ADDENDUM 1

DATE: 07/30/2018
PROJECT: Simulation Lab Renovation
ITB NO: 744-R1825
OWNER: The University of Texas Health Science Center at Houston
TO: Prospective Proposers

PROJECT'S NAME: Simulation Lab

Documents have been updated to reflect coordination, constructability review, building envelope review and UTHSC review. See list of documents below and attached narrative of changes.

ED3.0

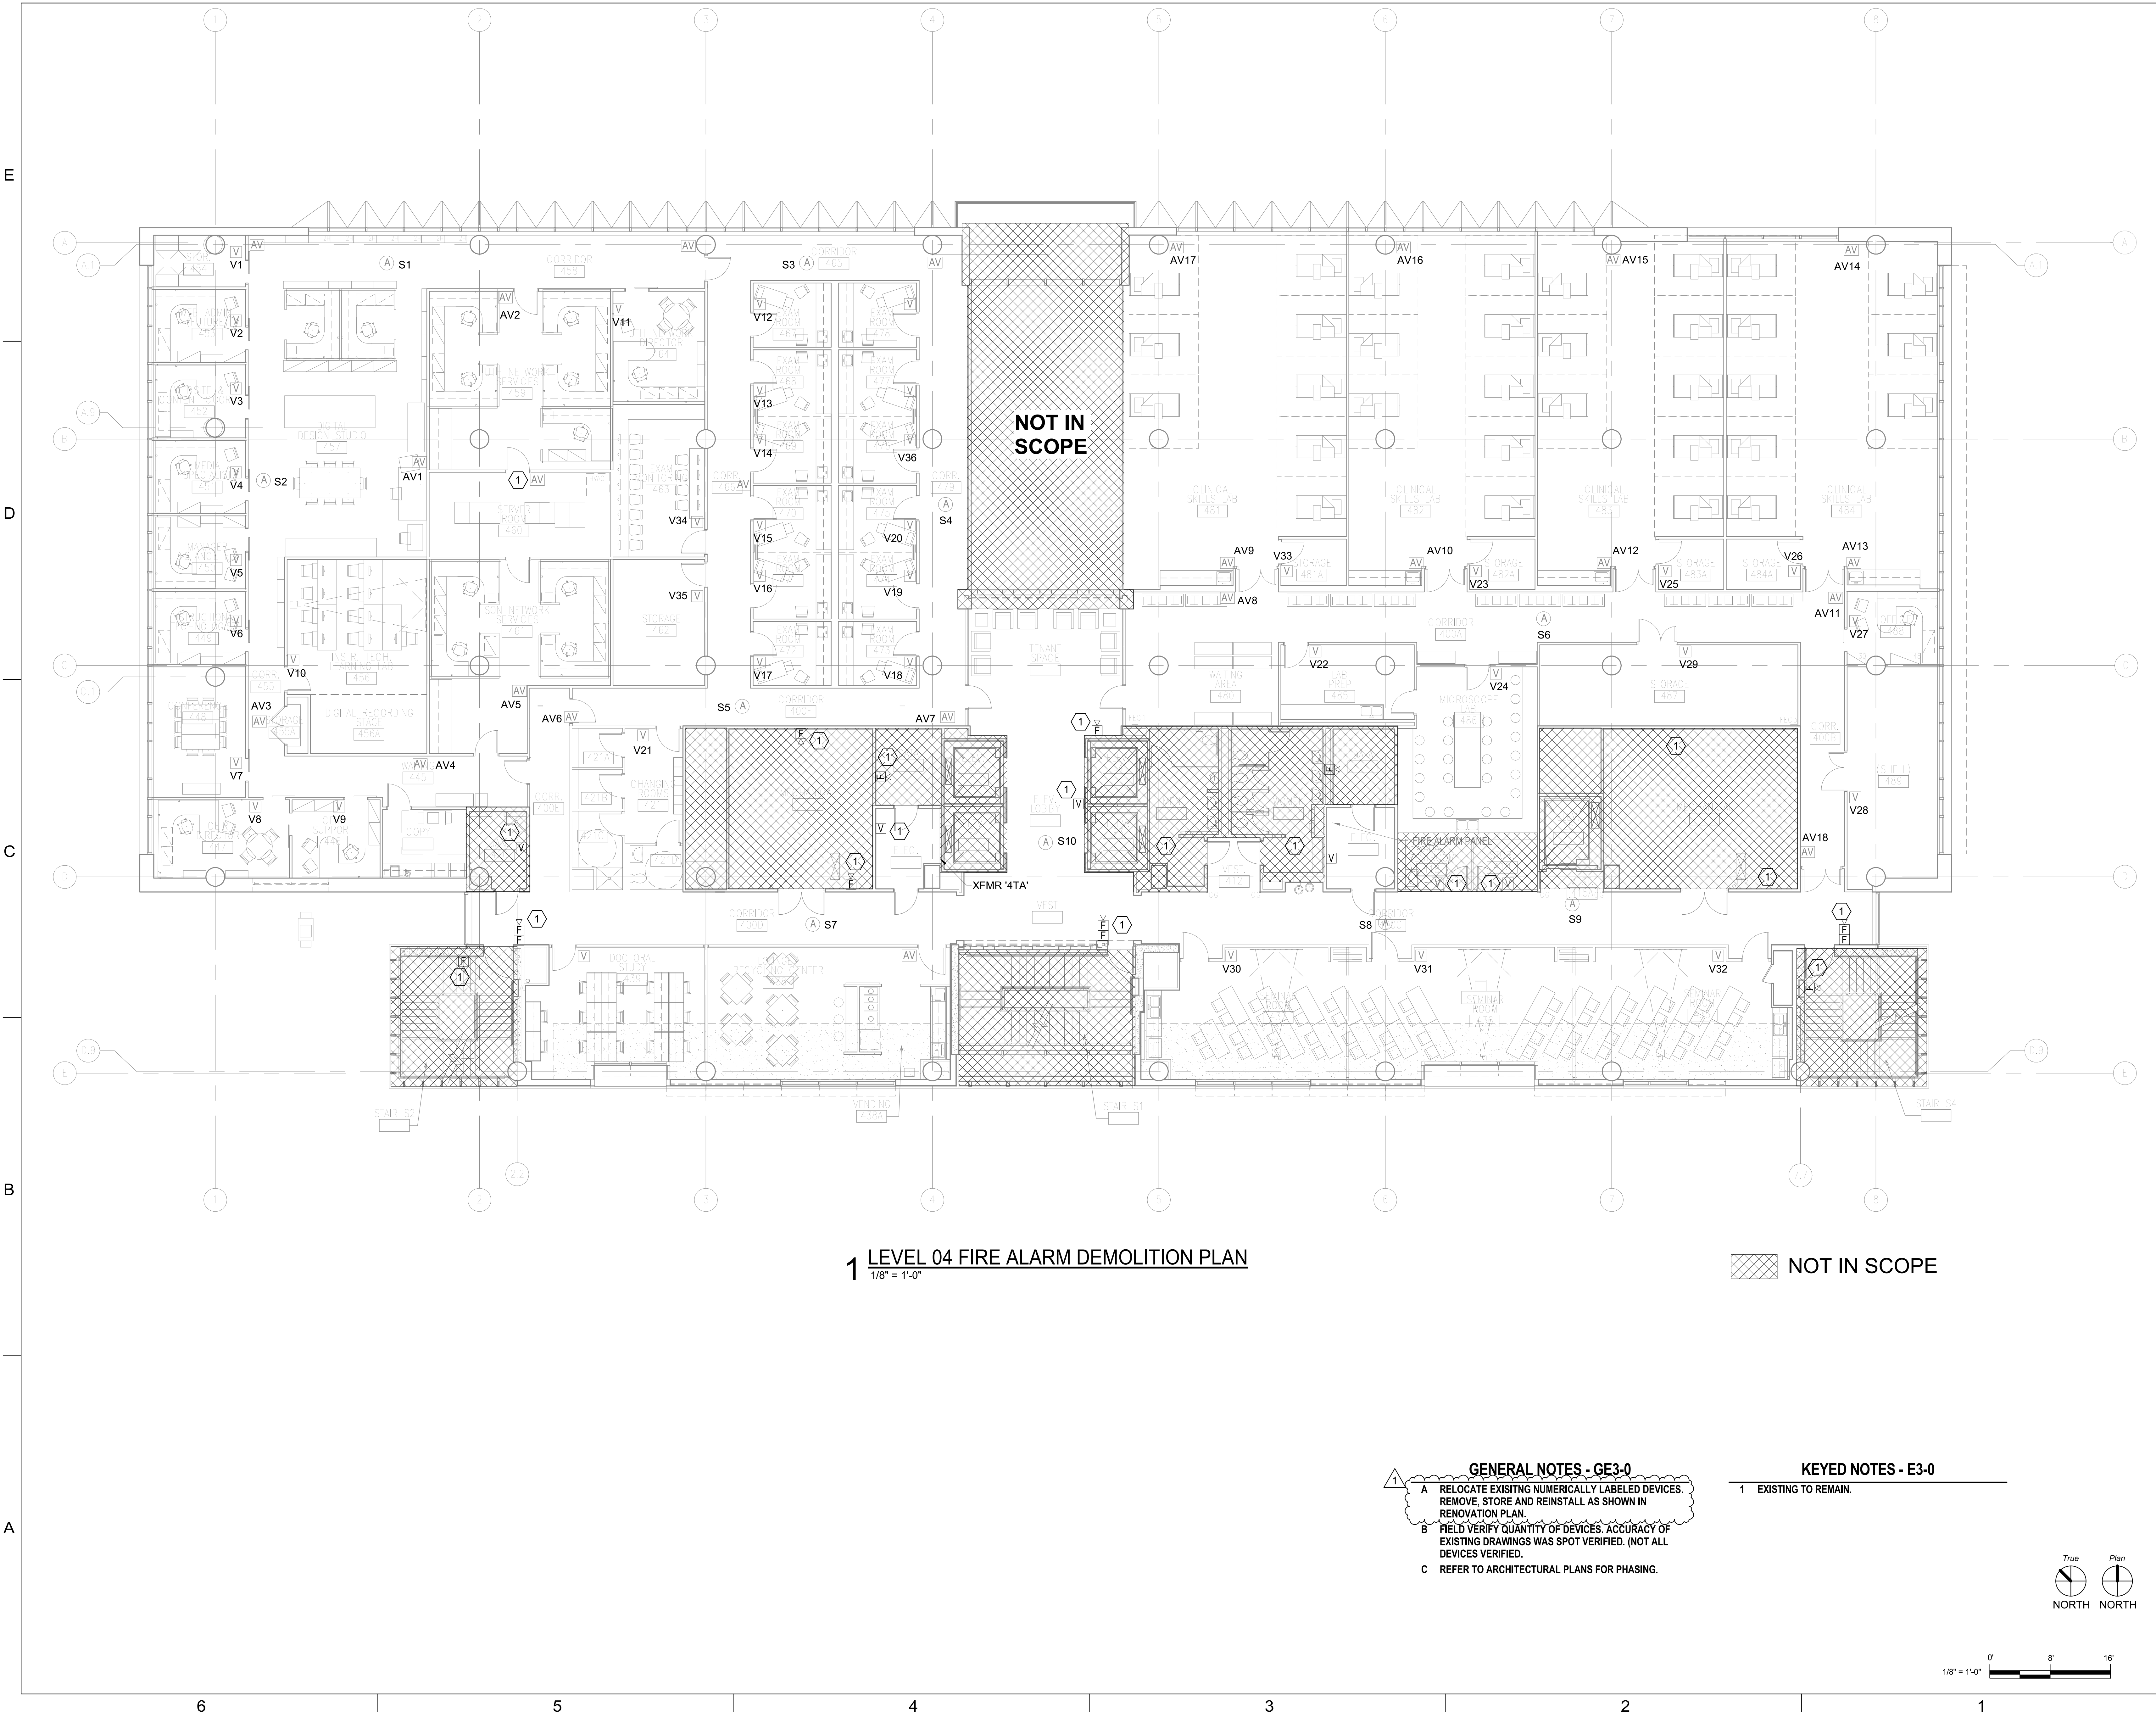
SHEET	VIEW	DESCRIPTION
E0.1		Added photoelectric switch symbol.
E0.3		Revised luminaire schedule.
E1.1		Added keyed notes #4. Revised lighting in home health.
E2.1		Added keyed notes #10. Added new thermal zone circuiting brackets.
E6.0		Revised occupancy sensor wiring detail. Revised mock emergency contactor detail.
E7.0		Revised notes section on each panel.
E7.1		Revised notes section on panels 4LB Existing and 4LB.
ED2.0		Added keyed notes #5. Revised some locations of keyed note #4.
ED3.0		Revised general notes, paragraph A.

DRAWING TITLE
LEVEL 4 PLUMBING RENOVATION PLAN
DRAWING NUMBER
P2.4

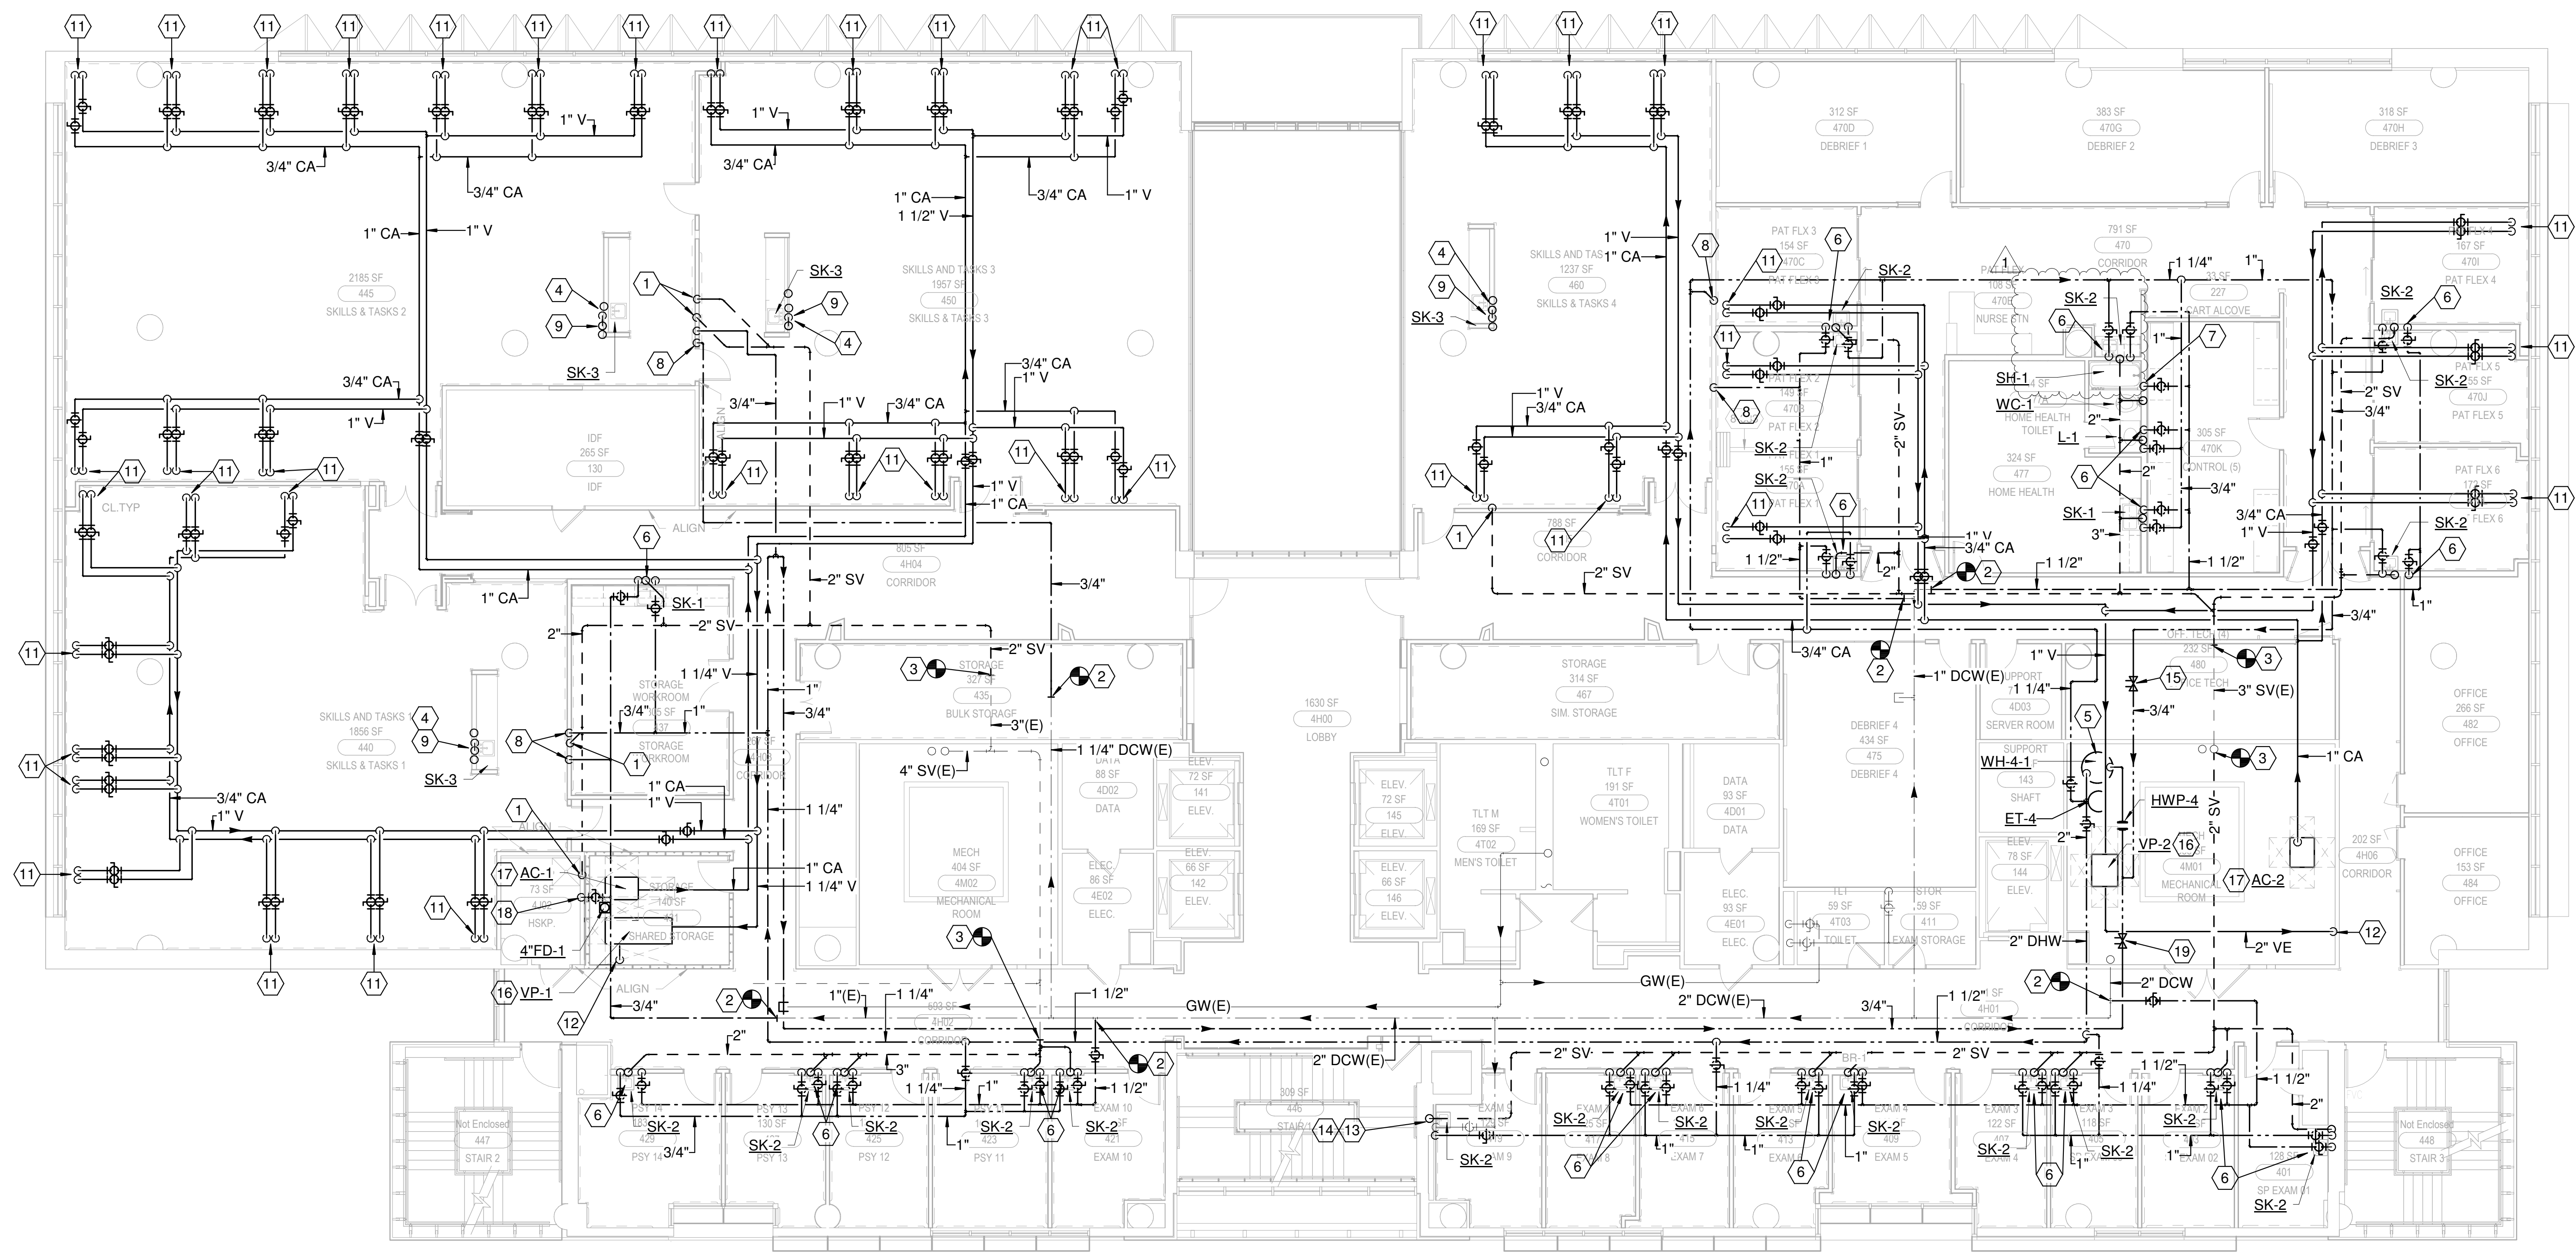
SHEET	VIEW	DESCRIPTION
PU2-4		Relocated plan west's vacuum exhaust discharge. Shifted piping affected by sink relocation.
P2-4		Shifted piping affected by sink relocation.
